Access Compliance Report Public Rights-of-Way (Curb Ramps)

Main Street: BELLFLOWER_ST		Cross Street: SNAPDRAGON_ST		Location:	NW
ADA ID: RPAT211101131115	Ramp Type: Type 4 - Parallel	Initial Pass/Fail: Fail	Overall Compliance: No	Severity Score:	2
Codes/Mitigation Info/Possible Solution			Field Measurements/Component Compliance

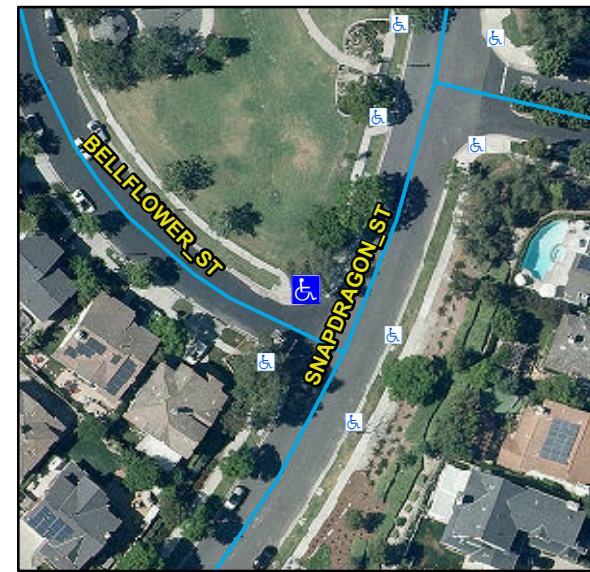
R304.2.2, R204.3, R304.5.3, STD 1115

Compliance	Description	Data	Compliance	Description	Data
N/A	Ramp Length LT (in)	109	N/A	Ramp Length RT (in)	100
Yes	Ramp Width LT (in)	90	Yes	Ramp Width RT (in)	91
Yes	Ramp Run Slope LT (%)	3.5	Yes	Ramp Run Slope RT (%)	5.9
No	Ramp Cross Slope LT (%)	2.3	Yes	Ramp Cross Slope RT (%)	0.8
N/A	Landing Present	N/A	N/A	DWS Provided	N/A
N/A	Landing Length (in)	N/A	N/A	DWS Contrast	N/A
N/A	Landing Width (in)	N/A	N/A	DWS Length (in)	N/A
N/A	Landing Run Slope (%)	N/A	N/A	DWS Full Width	N/A
N/A	Landing Cross Slope (%)	N/A		DWS Offset Type	N/A
N/A	Landing Movement Obstructed?	N/A	N/A	DWS Offset Left (in)	N/A
	Landing Movement Type	N/A	N/A	DWS Offset Right (in)	N/A
N/A	Landing Shared	N/A			
N/A	Clear Space	Yes			
N/A	Clear Space To Crosswalk (in)	N/A			
N/A	Marked Crosswalk 1	No	N/A	Marked Crosswalk 2	No
	Crossing 1 Direction	SW		Crossing 2 Direction	SE
	Marked Crosswalk 1 Width (in)	N/A		Marked Crosswalk 2 Width (in)	N/A

Remove & Replace Curb Ramp With Two New Directional Ramps or Equivalent.
